Access Compliance Report Public Rights-of-Way (Curb Ramps)

Main Street: WILSON_ST Cross Street: ROOSEVELT_AVE Location: NE

ADA ID: RPRK211001140226 Ramp Type: Type 1 - Perpendicular Diagonal Initial Pass/Fail: Fail Overall Compliance: No Severity Score: 30

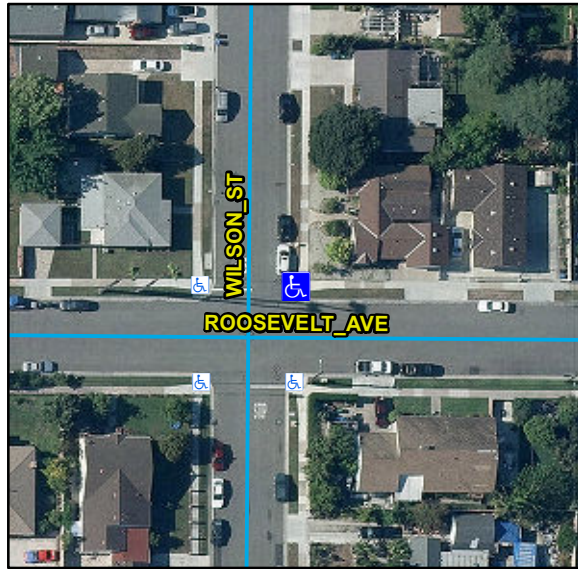
R304.2.2, R304.5.3, STD 1115

Compliance	Description	Data	Compliance	Description	Data
N/A	Ramp Length (in)	68	N/A	Flare Type LT	
Yes	Ramp Width (in)	48			N/A
Yes	Ramp Run Slope (%)	1.5	N/A	Flare Slope LT (%)	N/A
No	Ramp Cross Slope (%)	11.4	N/A	Flare Traversable LT	N/A
N/A	Landing Present	N/A	N/A	Flare Type RT	
N/A	Landing Length (in)	N/A			N/A
N/A	Landing Width (in)	N/A	N/A	Flare Slope RT (%)	N/A
N/A	Landing Run Slope (%)	N/A	N/A	Flare Traversable RT	N/A
N/A	Landing Cross Slope (%)	N/A	N/A	DWS Provided	N/A
N/A	Landing Movement Obstructed?	N/A	N/A	DWS Contrast	N/A
	Landing Movement Type	N/A	N/A	DWS Length (in)	N/A
N/A	Landing Shared	N/A	N/A	DWS Full Width	N/A
N/A	Clear Space	Yes	N/A	DWS Offset Left (in)	N/A
N/A	Clear Space To Crosswalk (in)	N/A	N/A	DWS Offset Right (in)	N/A
N/A	Marked Crosswalk 1	No	N/A	Marked Crosswalk 2	No
	Crossing 1 Direction	W		Crossing 2 Direction	S
	Marked Crosswalk 1 Width (in)	N/A		Marked Crosswalk 2 Width (in)	N/A

N/A	Ramp Inside Crosswalk 1	N/A	Yes	Ramp Inside Crosswalk 2	N/A
	Crossing 1 Slope (%)	6.8		Crossing 2 Slope (%)	2.6
	Crossing 1 Cross Slope (%)	0.8		Crossing 2 Cross Slope (%)	0.6
N/A	Gutter Ponding	N/A	No	Curb Slope	11.3
Yes	Gutter Lip Height (in)	0		Road Run Slope (%)	2
N/A	Gutter Run Slope (%)	N/A		Road Cross Slope (%)	1.6
N/A	Gutter Cross Slope (%)	N/A			
Yes	Overall Surface Condition: Acceptable		Yes	Perp Joint Present	Yes
	Cross Gutter Present?	No		Spandrel Present?	No
	Replace Cross Gutter?	N/A		Replace Spandrel?	N/A

Remove & Replace Curb Ramp With Two New Directional Ramps or Equivalent.
